## ODOR CONTROL FACILITY IMPROVEMENTS PROJECT

Solicitation Number: CO-00704

Job No.: 22-6506

### ADDENDUM 2

DATE: MAY 2024  
PROJ: WJXN5100  
DWG: 05-E-201  
SHEET: 24 of 43

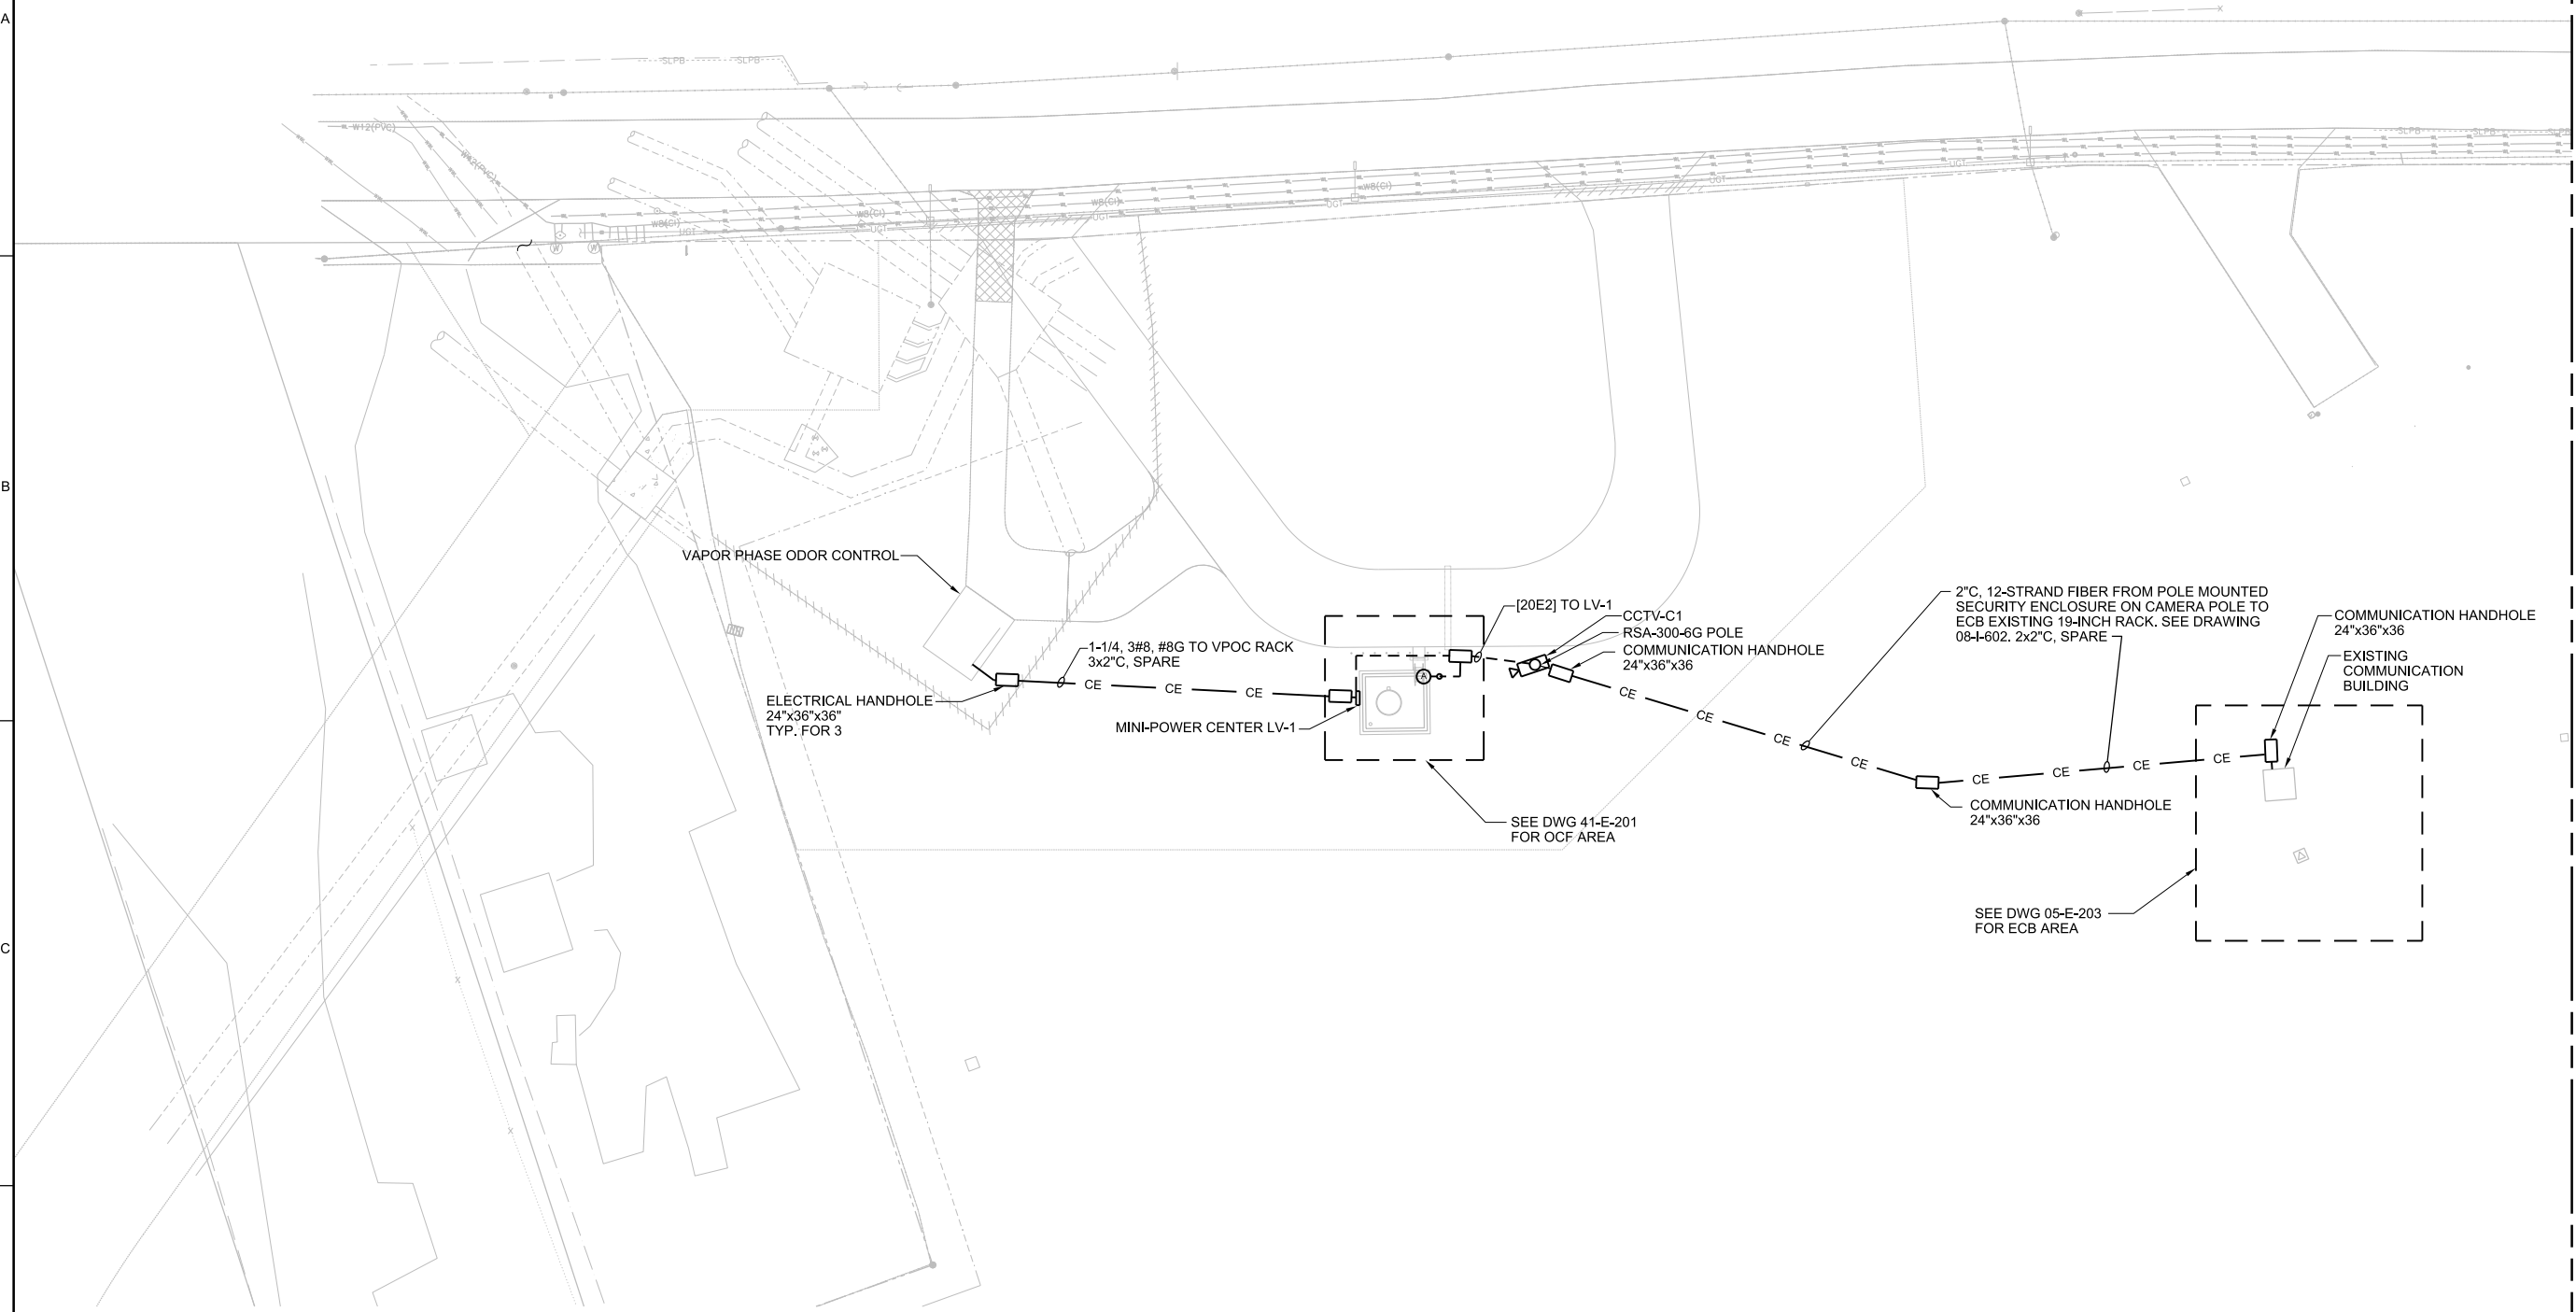
**16. Question: Please verify scale on the drawings for Rilling Road facilities. The Civil/Structural drawings are off by 2, could be related to half sized drawings, however, Electrical drawing 05-E-201 Site plan is off by a factor of 3.**

1. Rilling Road Drawing 05-E-201, Electrical Site Plan, remove in its entirety and replace it with the revised version attached to this addendum.
2. Rilling Road Drawing 05-L-201, Enlarged Tree Preservation Plan, remove in its entirety and replace with the revised version attached to this addendum.

*Rilling Road drawings are printed half-size. The scale on Electrical Drawing 05-E-201 has been corrected and the revised plan is included in this Addendum.*

**C7**  
 SHT 7 OF 34

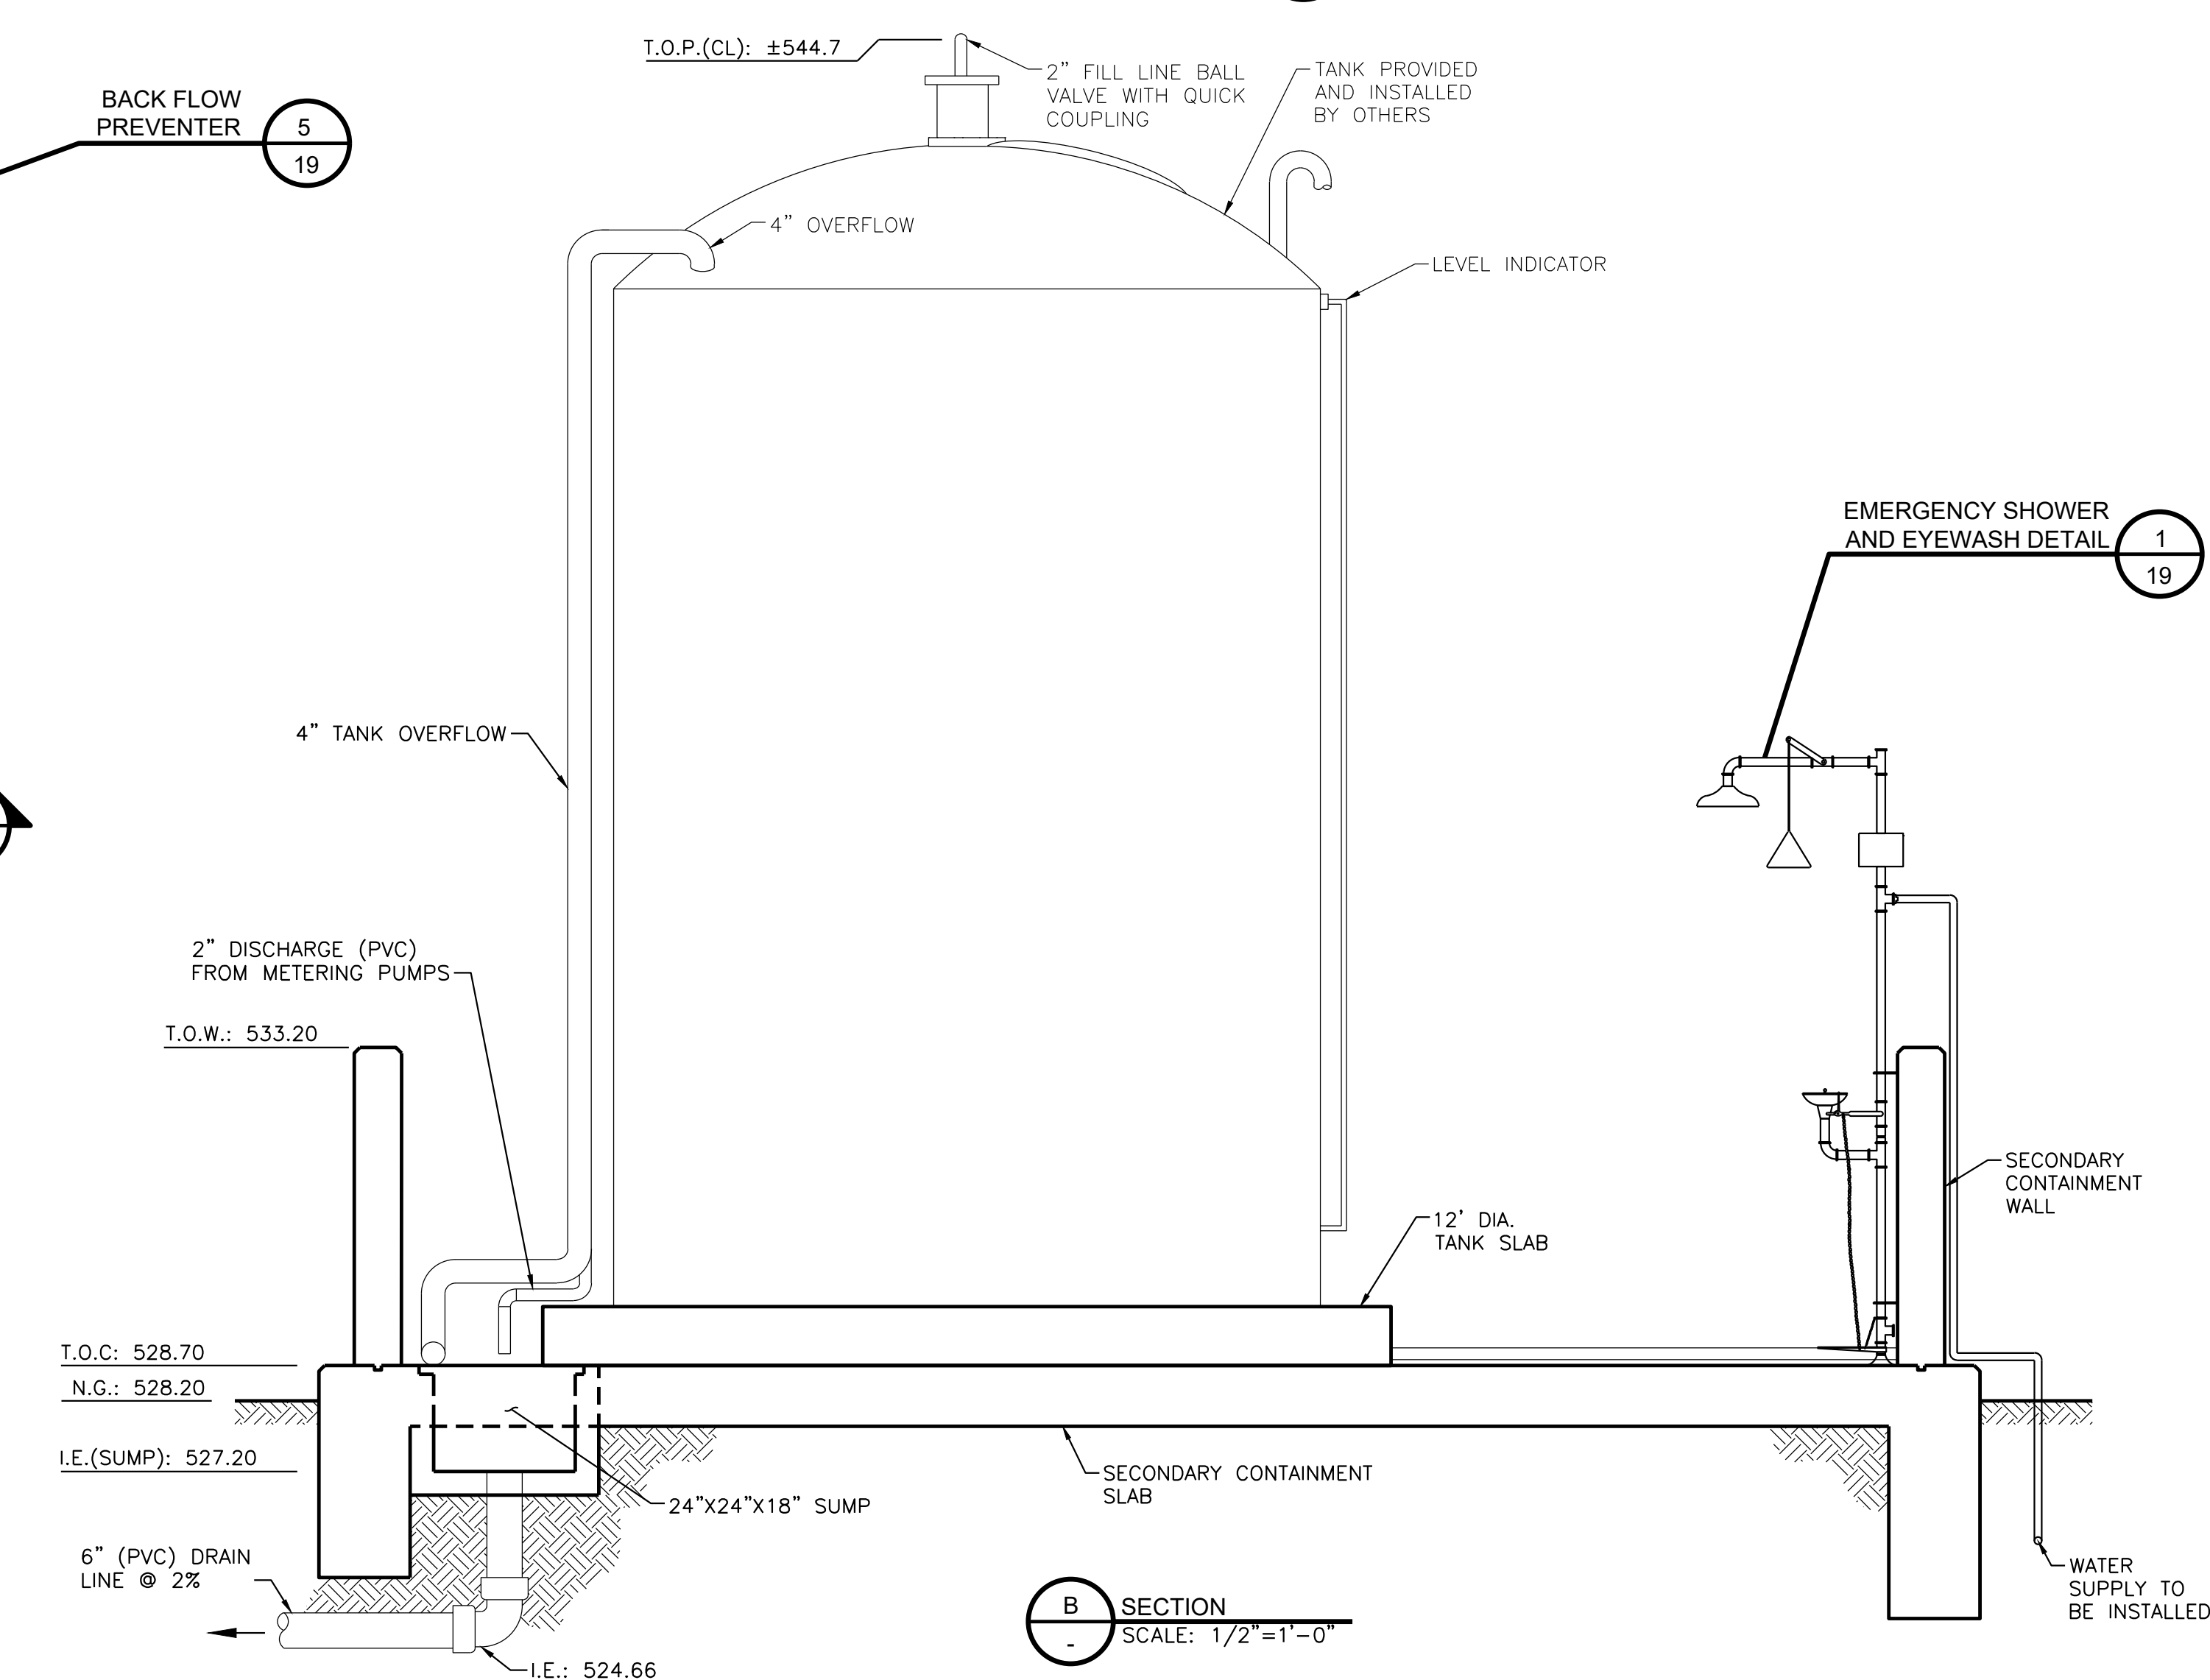
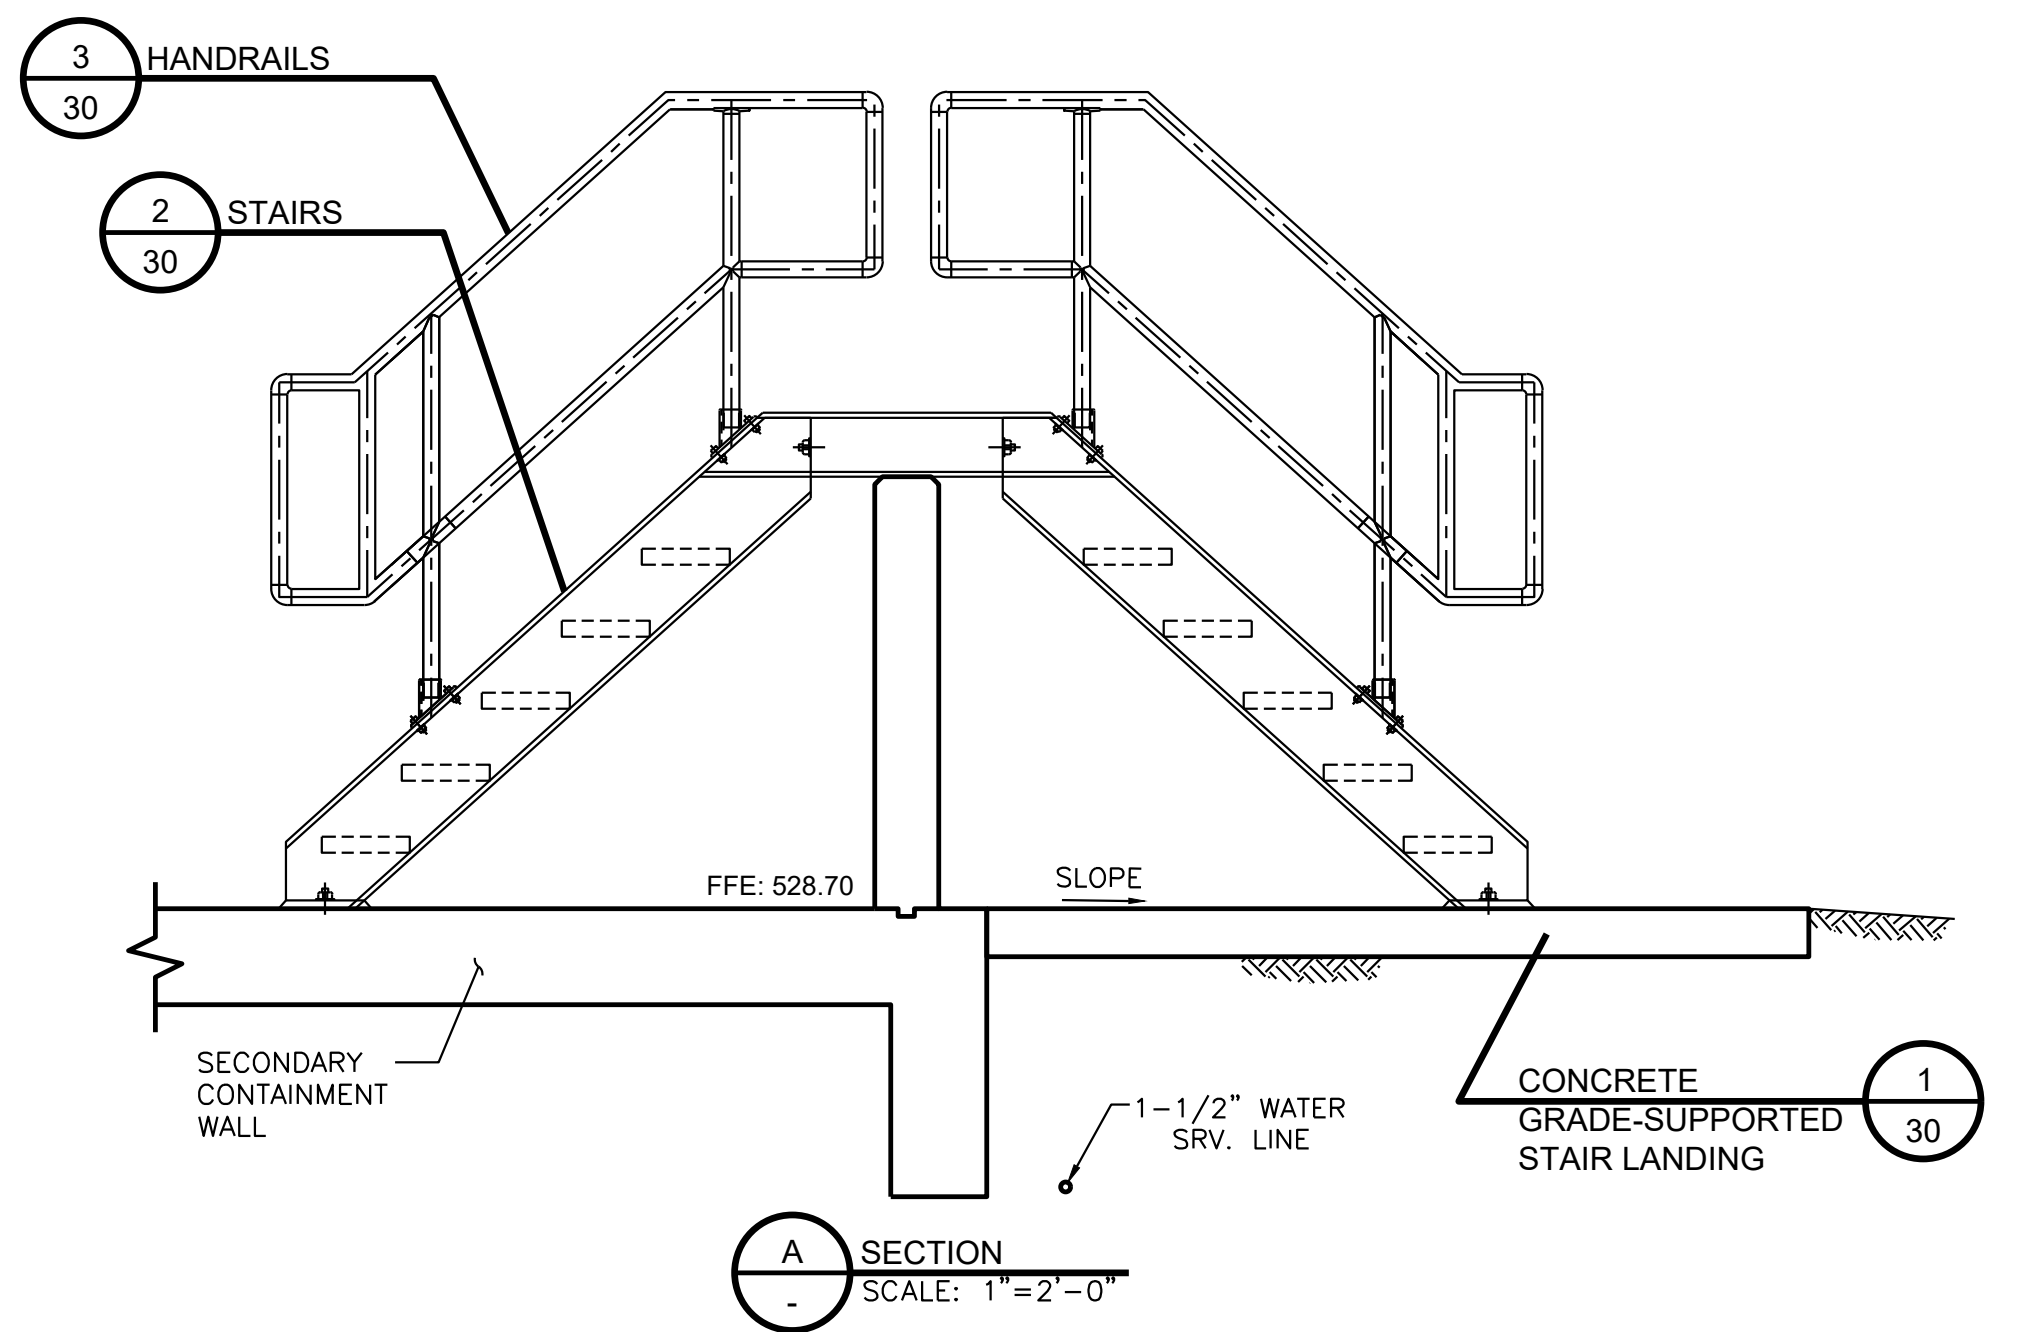
3. Rilling Road Drawing 41-D-501, Liquid Treatment OCF Details, remove in its entirety and replace with the revised version attached to this Addendum.
4. Leon Creek Drawing C7, Mechanical and Structural Plan and Section, remove in its entirety and replace it with the revised version attached to this addendum.

- SHEET NOTES:**
- CHEMICAL STORAGE TANK, CHEMICAL METERING PUMPS, CONTROLS SKID, CHEMICAL INTERCONNECTING PIPING, 3" FILL LINE FROM THE CHEMICAL FILL STATION TO THE CHEMICAL TANK, AND VALVES WILL BE PROVIDED AND INSTALLED BY OTHERS (SAWS VENDOR) UNDER A SEPARATE CONTRACT.
  - ALL OTHER WORK TO INCLUDE SECONDARY CONTAINMENT STRUCTURE, TANK SLAB, DRAIN SUMP, STAIRWAY, EMERGENCY SHOWER AND EYEWASH STATION, HOSE VALVE, FREESTANDING HOSE RACK, CHEMICAL FILL STATION, FILL STATION 1 1/2" DRAIN LINE, FILL STATION BALL VALVE W/QUICK COUPLING, PIPE BOLLARDS, WATER SERVICE LATERAL, AND PVC DRAIN LINE WILL BE PROVIDED BY THE CONTRACTOR.
  - REFER TO SHEET 19 FOR MECHANICAL DETAILS.
  - REFER TO SHEETS 28, 29 AND 30 FOR STRUCTURAL DETAILS.
  - SECONDARY CONTAINMENT CONCRETE STRUCTURE WILL BE PAINTED BY THE FERRIC SUPPLIER UNDER A SEPARATE CONTRACT.
